Re: State Center Fire Department  
Renovation & Addition – Redesign  
109 E Main Street  
State Center, Iowa 50247

## ADDENDUM #02

January 09, 2026

## SCFD – Addendum #2 Changes

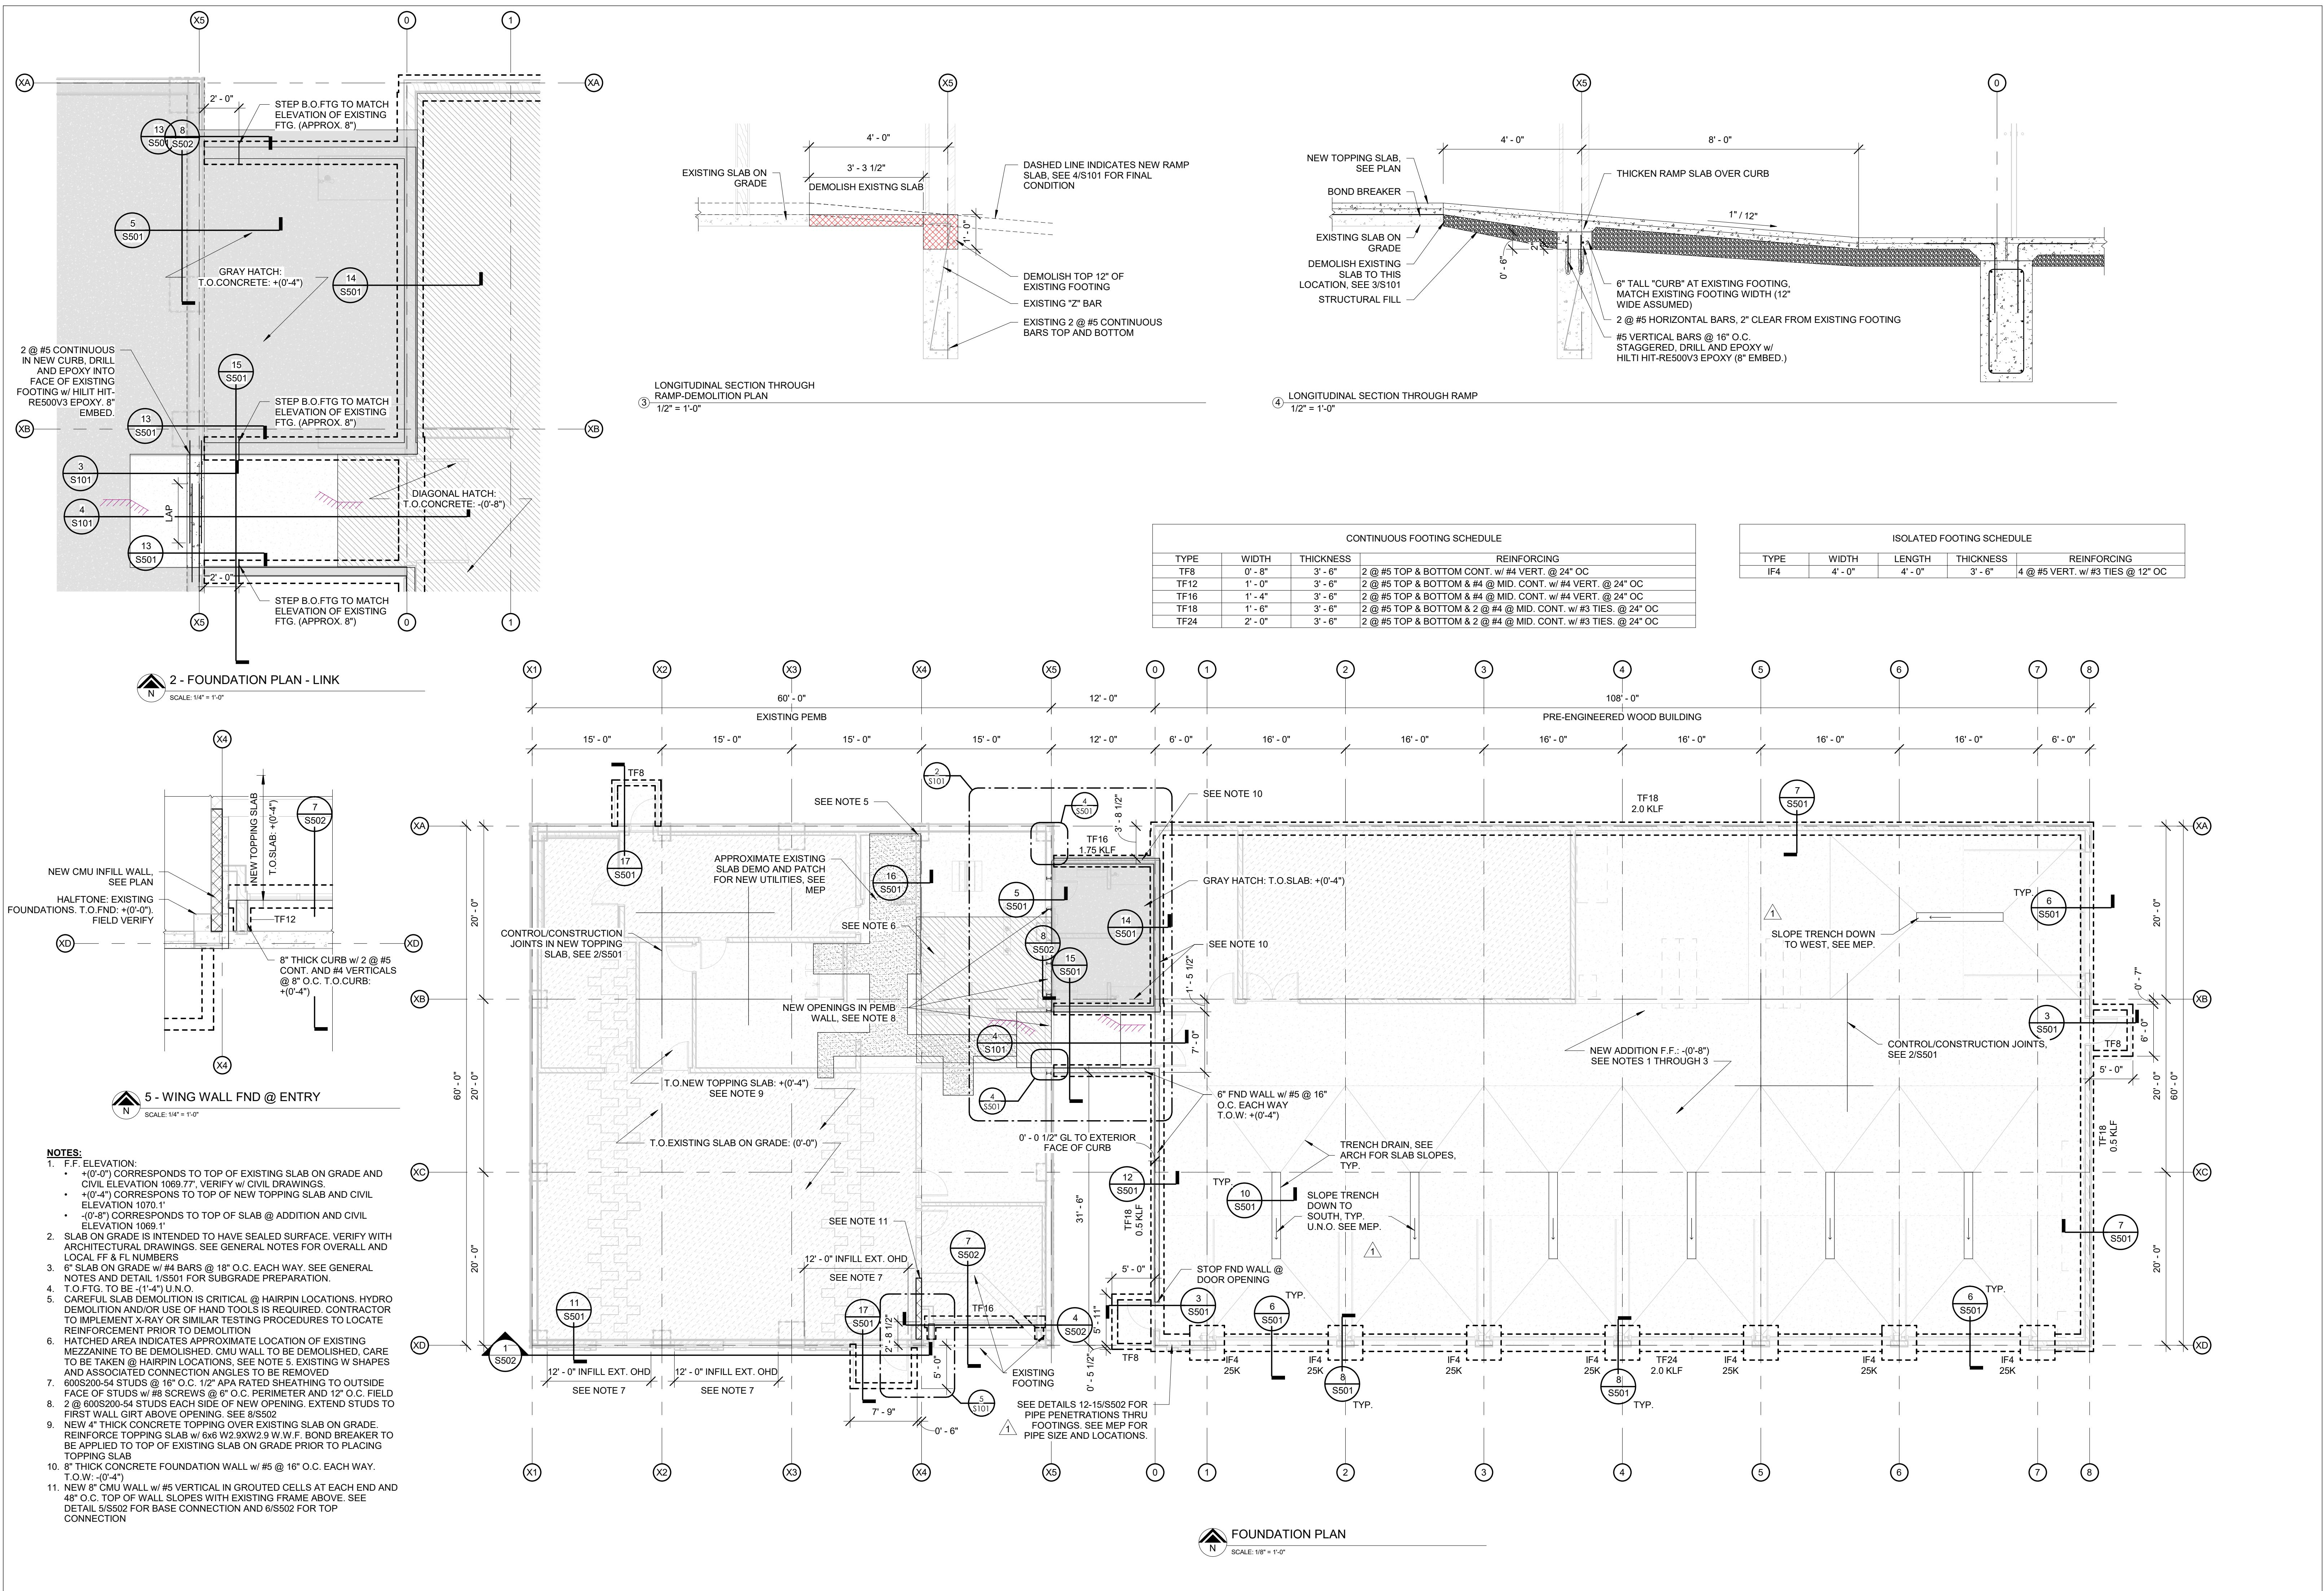
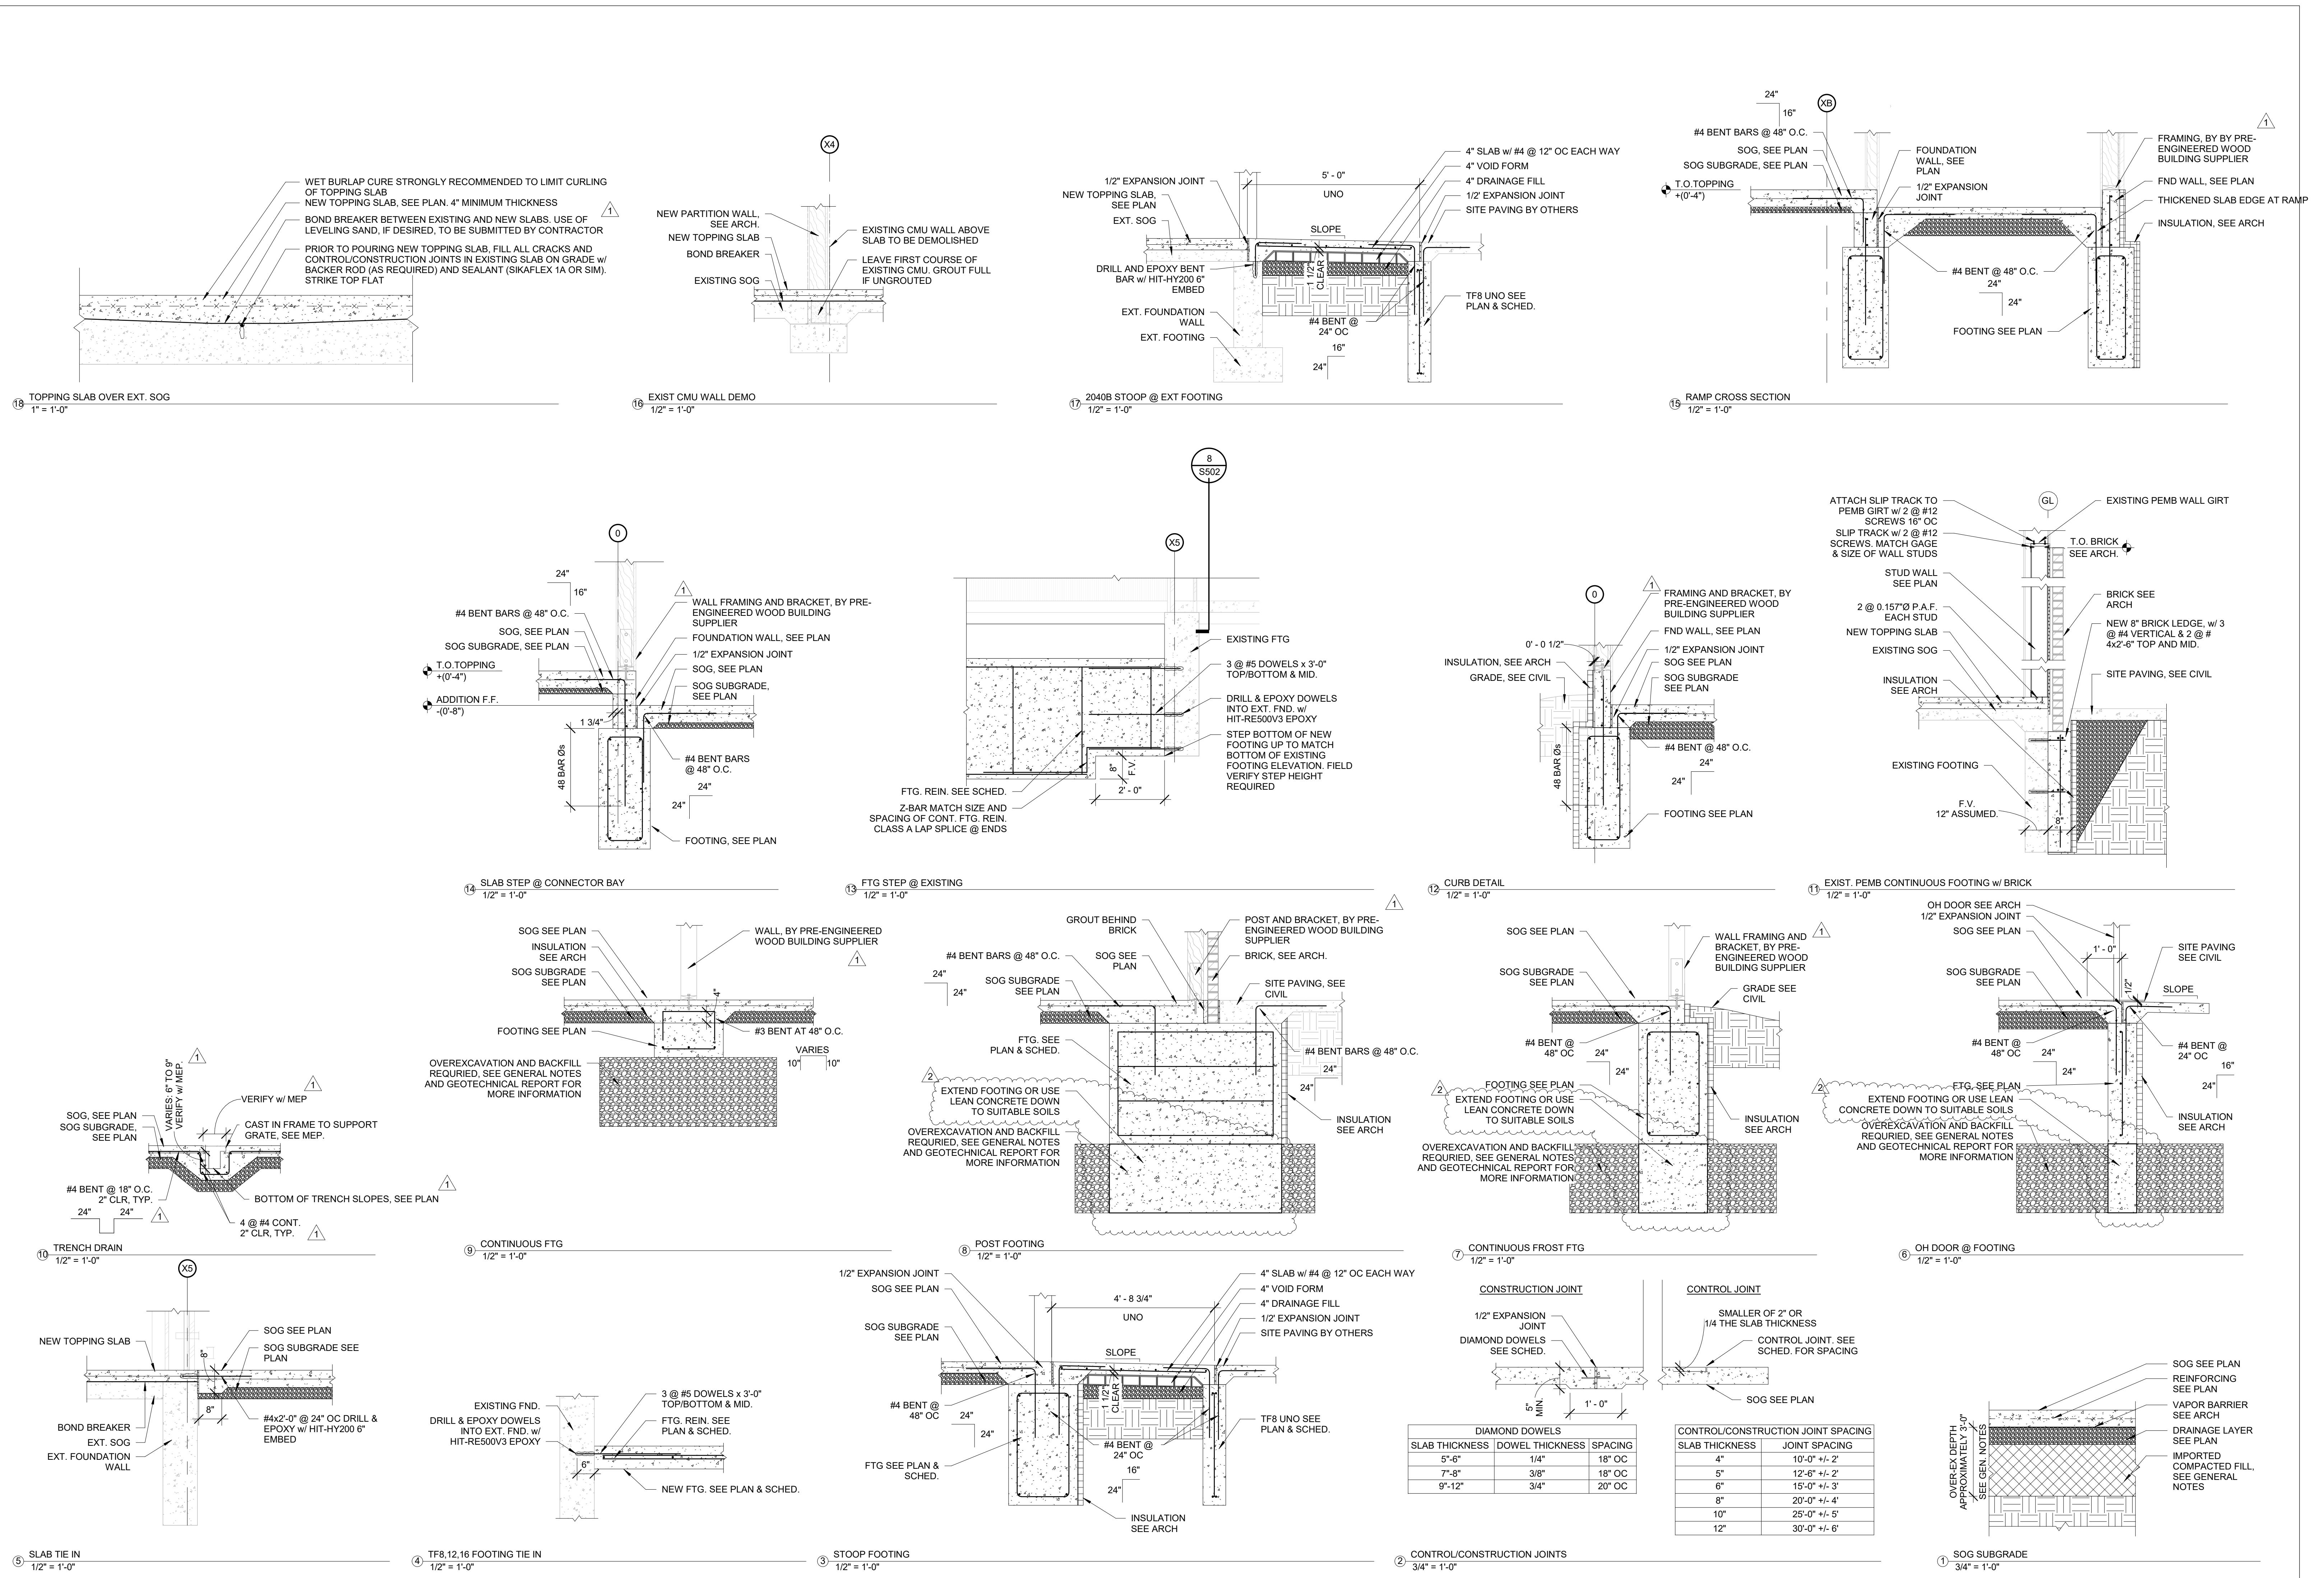
- Sheet S001
  - Revised Note S.2 in Concrete and Reinforcement General Notes to indicate drainage fill thickness under floor slab
- Sheet S101
  - No changes
- Sheet S102
  - No changes
- Sheet S201
  - Revised notes and shaded area to more accurately reflect approximate over-excavation locations
- Sheet S501
  - Revised Details 6, 7, & 8 to clarify trench footing construction if unsuitable soils are found. Option of extended footing or using lean concrete through unsuitable soils down to suitable soils are given. This is also found in the geotechnical report.
- Sheet S502
  - No changes
